Appendix 2: Geology and hydrogeology

Statement of Evidence		ABP Ref No. PL06F.PA0018
Murphy Environmental Hollywood Ltd. Proposed Integrated Waste Management Facility		
Expert Name:	Eugene Daly, Jenny Lightfoot, Gareth LI Jones and Catherine Buckley

Statement of Evidence of Eugene Daly, Jenny Lightfoot,
Gareth LI Jones and Catherine Buckley

Figure 2: Surface water catchments

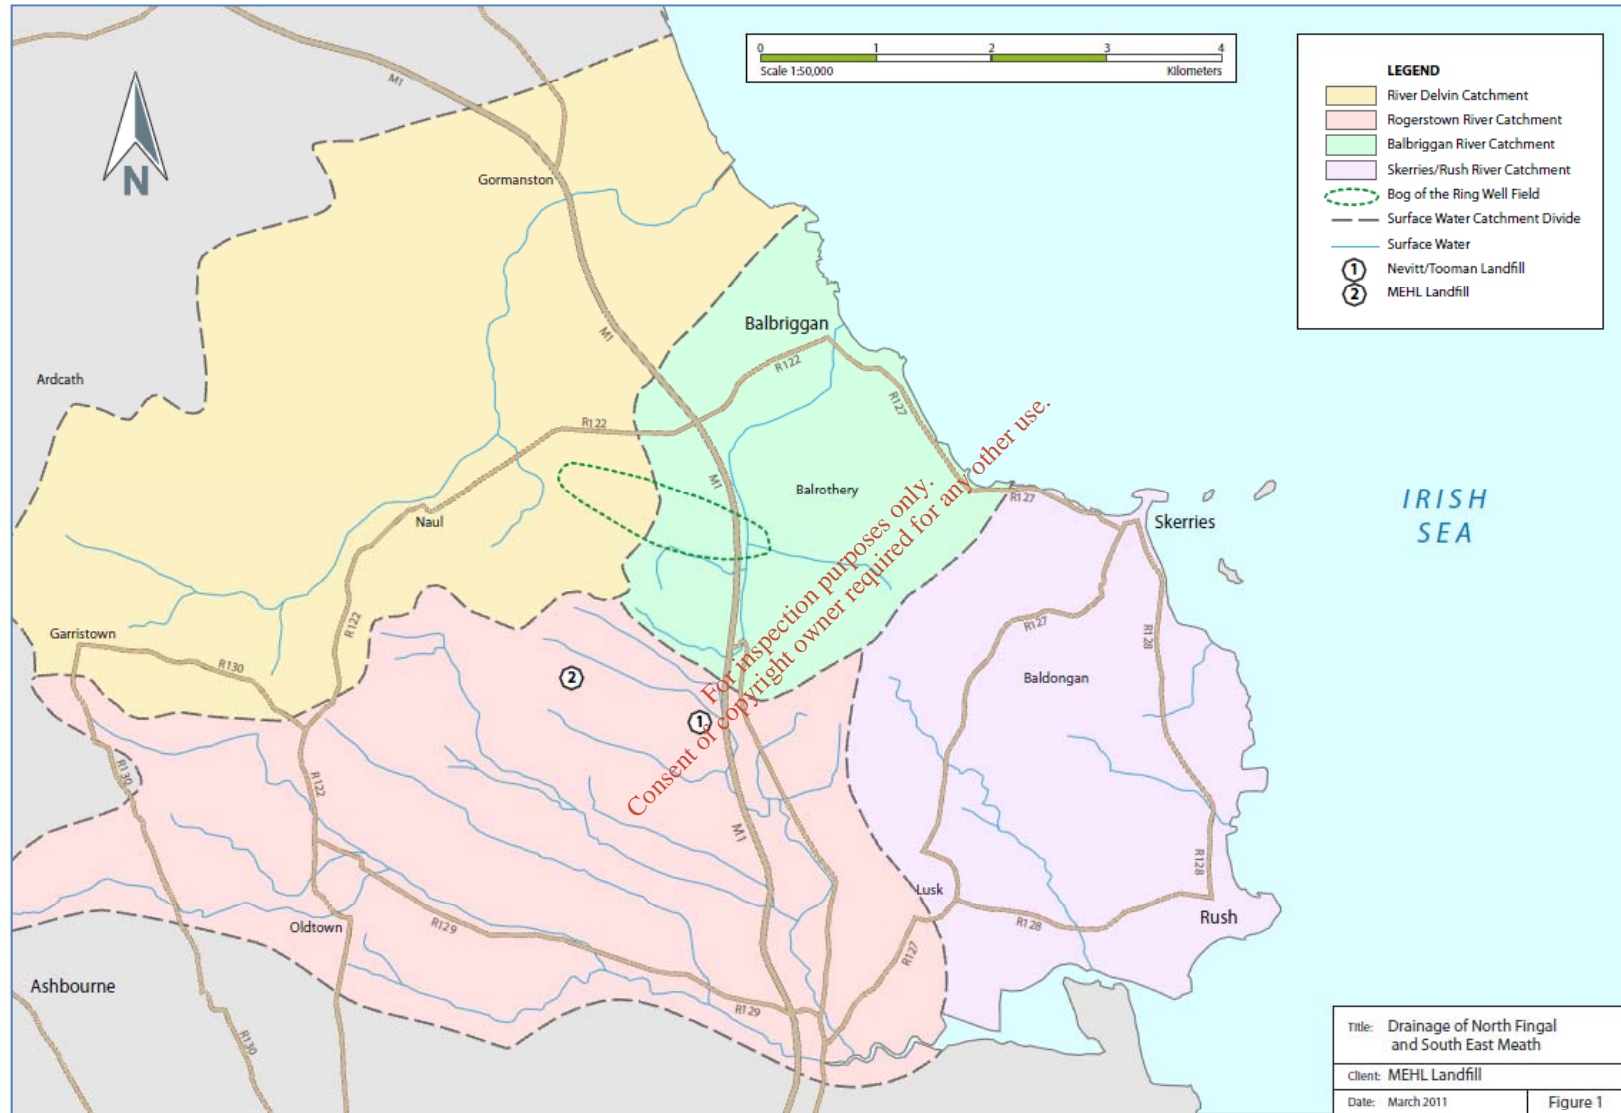
'The extent of the north-south trending fault identified on the site has not been adequately defined by the applicant. The geological survey of the site suggests that the north-south trending fault "...is probably a continuation of the fault that the GSI shows on their sheet 13 (McConnell et al 2004) immediately north of the Hollywood site" ((Conodate, Nov 2009). This may provide a direct link between the site and the Bog of the Ring supply.'

- The Nevitt / Tooman and the MEHL landfills are separated from the Bog of the Ring catchment by a no flow groundwater divide as shown on Figure 2 above.
- The GSI in a letter to the EPA, in response to a request for information from the EPA in relation to the licensing of the Nevitt / Tooman landfill, dated 24th October 2006 and describing this groundwater divide states;

a regional scale discharges to surface water and the Rogerstown Estuary a further 6km to the south east (refer Figure 2). There is no flow across the divide itself.'

Figure 3: Groundwater flow pattern

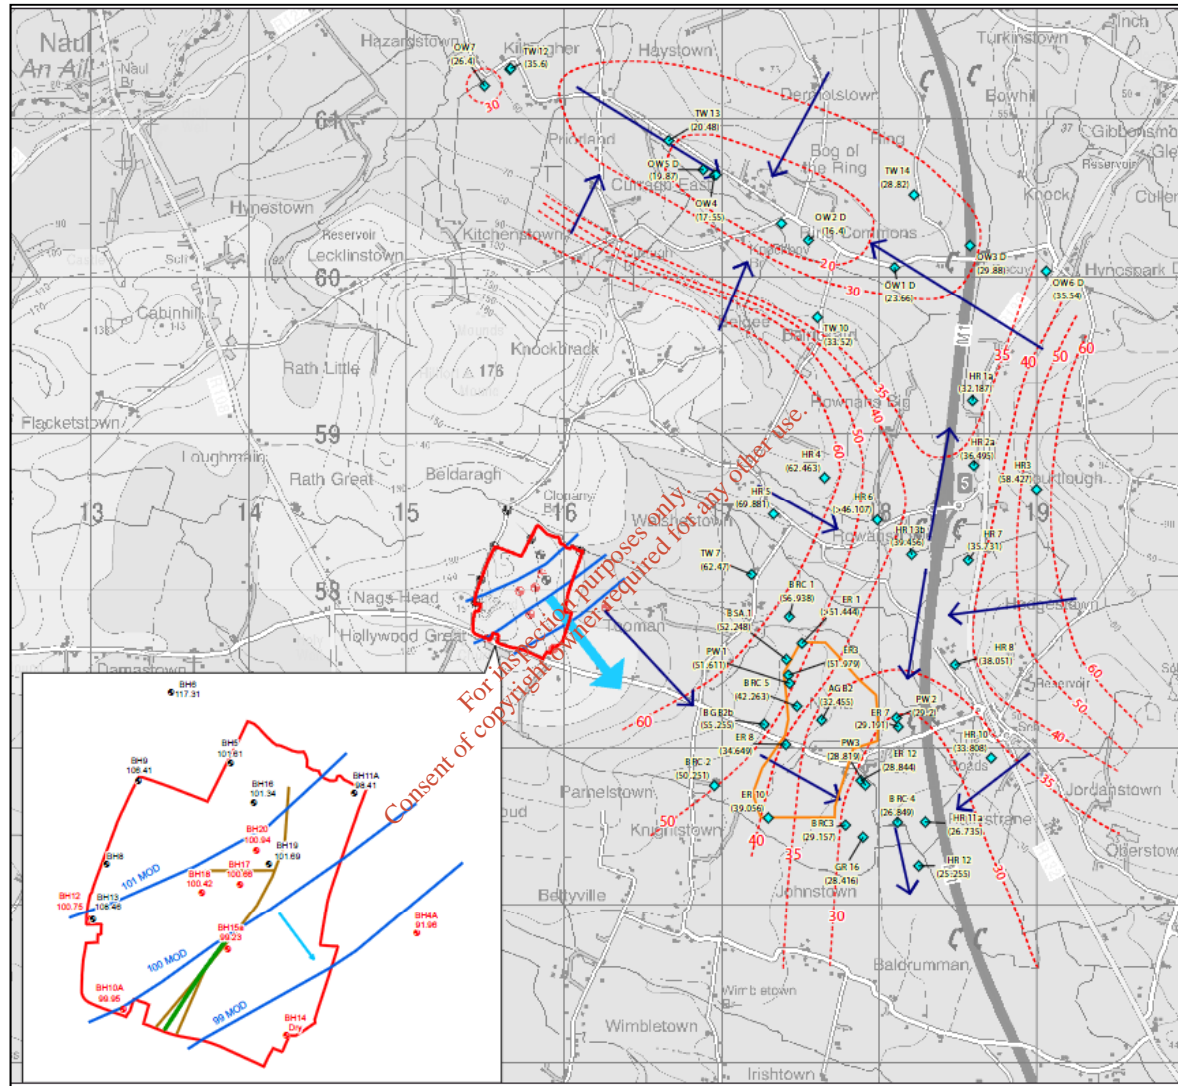
'Groundwater flow mapping conducted by the applicant is deficient and does not provide sufficient information to demonstrate that the Bog of the Ring is not At Risk from the proposed development.'

- MEHL have sufficient information to characterise the groundwater flow regime on their site
- The groundwater flow direction measured at the MEHL site is shown in the accompanying Figure 3 in the context of the regional groundwater flow pattern as reported at the Nevitt / Tooman landfill. The groundwater flow direction is to the south-east.
- The Bog of the Ring water supply scheme is not at risk from the proposed landfill.
